Castle Hill Huddersfield,
HD4 6TA

Combined Stage 1 -2 Road Safety
Audit

CLIENT: Castle Hill Hotel Heritage Limited
PROJECT TITLE: Castle Hill Huddersfield,
 HD4 6TA
REPORT TITLE: Combined Stage 1 -2 Road Safety Audit
PROJECT REFERENCE: 156199
DOCUMENT NUMBER: 002
ISSUE NUMBER: 01
DATE: August 2024

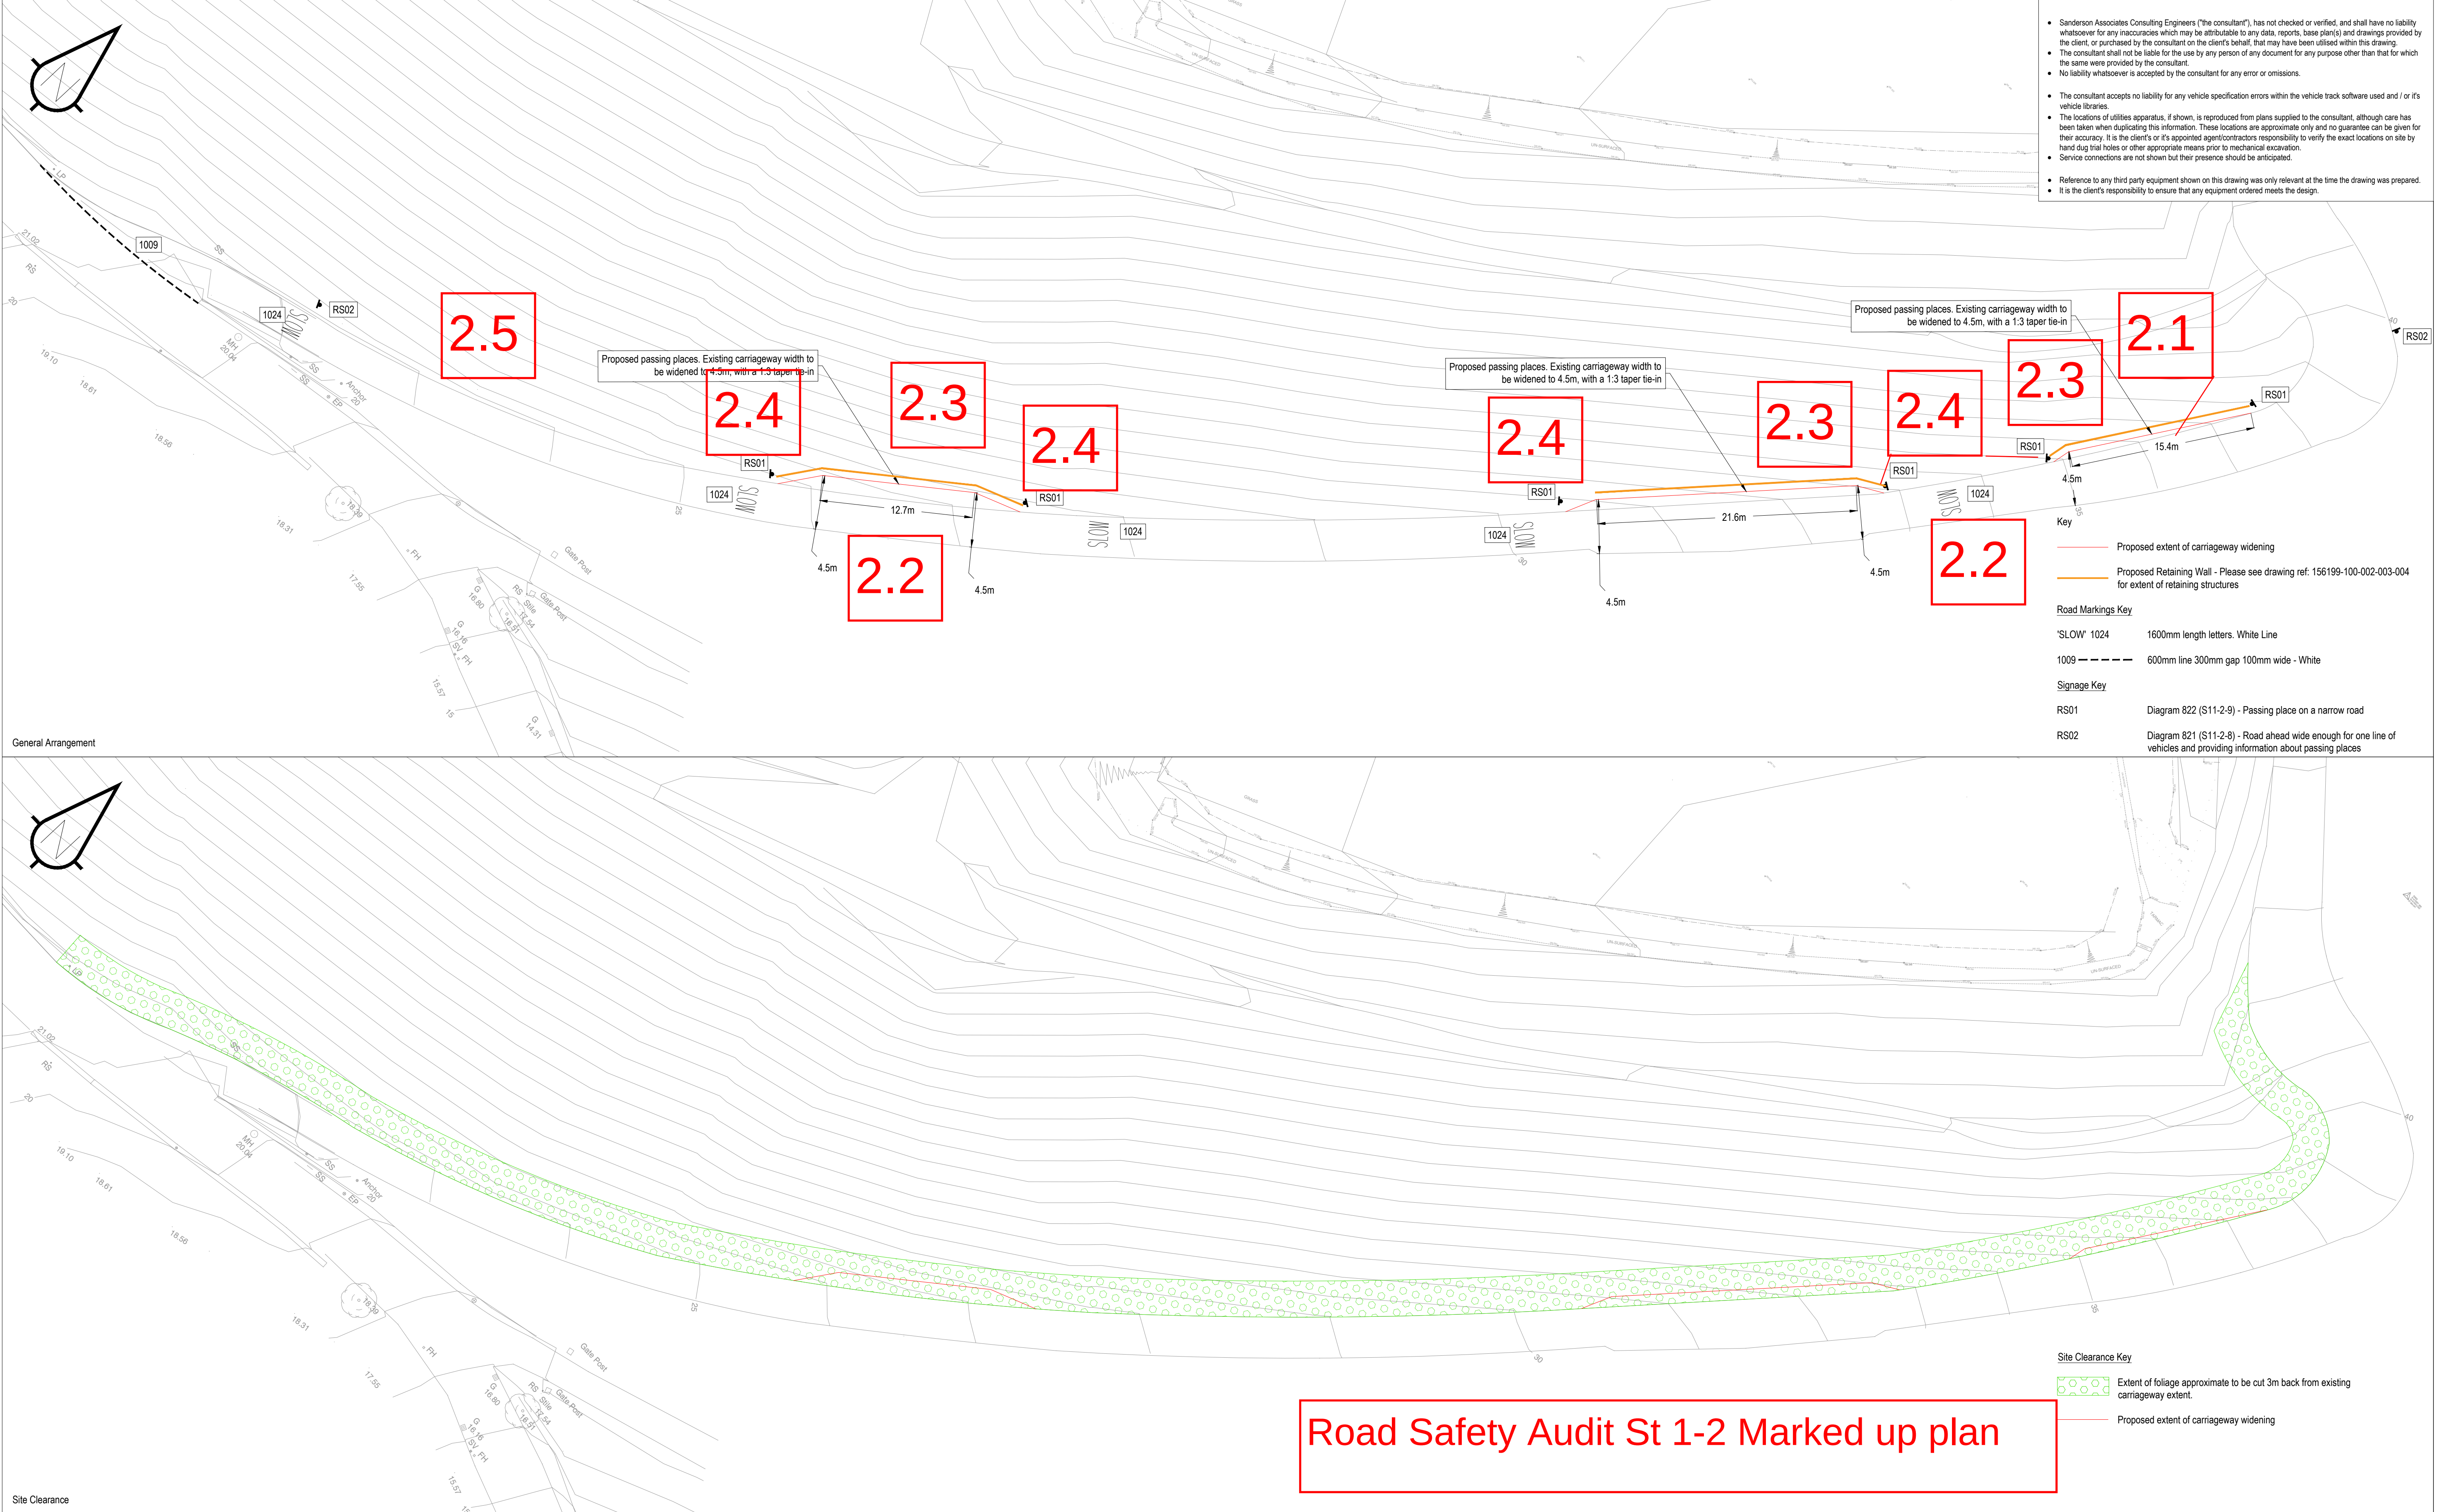
Summary: Existing gully not shown on drawing adjacent to passing place widening.

There is an existing road gully adjacent to passing place widening which will fall in the wheel track of vehicles and powered two wheelers. The concern is that if adequate drainage is not provided it could lead to skid or loss of control incidents in the carriageway during periods of inclement weather. It is noted that vehicles could also be braking in this area on a downhill approach to the passing place.

Summary: The drawing 156199-700-001 shows to areas of carriageway surfacing and description of the construction materials and thicknesses. However, no details are provided of the PSV value for the surface course aggregate. The concern is that vehicles will be slowing and braking in these areas in conjunction with the gradient of the road. If inappropriate levels of skid resistance are provided this could lead to skidding or loss of control type incidents in conflict with vehicles or pedestrians since they could share the same surface.

Summary: The drawing 156199-700-001 shows three areas of 0.45 wide verge between the parking bay and retaining walls in conjunction with the placing place width of 4.5m. The concern is if vegetation grows in the verge area, it could lead to drivers providing more clearance against the verge (to avoid their vehicle scratched or damaged) thereby effectively reducing the 4.5m width for passing. The result of this could lead to head-on offside collisions between vehicles and wing mirror clashes.

Summary: The drawings show 1 in 3 tapers to be provided at the ends of the passing places which may inhibit the manoeuvring of vehicles passed each other particularly the shorter southernmost passing bay. The concern is that two large cars may not have sufficient length to orientate parallel to each other with the 4.5m width and taking into account wing mirrors. The result of this could lead to head-on offside collisions between vehicles and wing mirror clashes. Furthermore, it could lead to the southbound vehicle overriding on the verge. It was also noted that in places the verge was lower, with a vertical drop adjacent to the carriageway, which could lead to damage to vehicle wheels and car bodies.

Summary: The drawing 156199-100-001 shows the area of existing foliage to be cleared and notes a strip 3m wide from the edge of carriageway. This is needed to assist in providing forward visibility between approaching vehicles and for drivers to use the passing places accordingly. The concern is that without appropriate visibility it could lead to drivers not making use of the passing places resulting in vehicles reversing as another vehicle approaches from behind with consequent rear shunt type incidents or head on offside vehicular collisions whilst vehicles try to pass each other. The drawing provides no details of the maintenance regime or the height to which the foliage should be cut and trimmed.

Recommendation: Reposition the gully against the channel line to intercept surface water.

Recommendation: Utilise surface course materials with appropriate skid resistant properties.

Recommendation: Utilise a surface material that inhibits vegetation growth.

Recommendation: Provide appropriate taper lengths to allow vehicles to manoeuvre passed each other and raise verge levels where needed adjacent to the passing places.

Recommendation: Provide details of the proposed maintenance regime and heights to which foliage should be cut and trimmed.
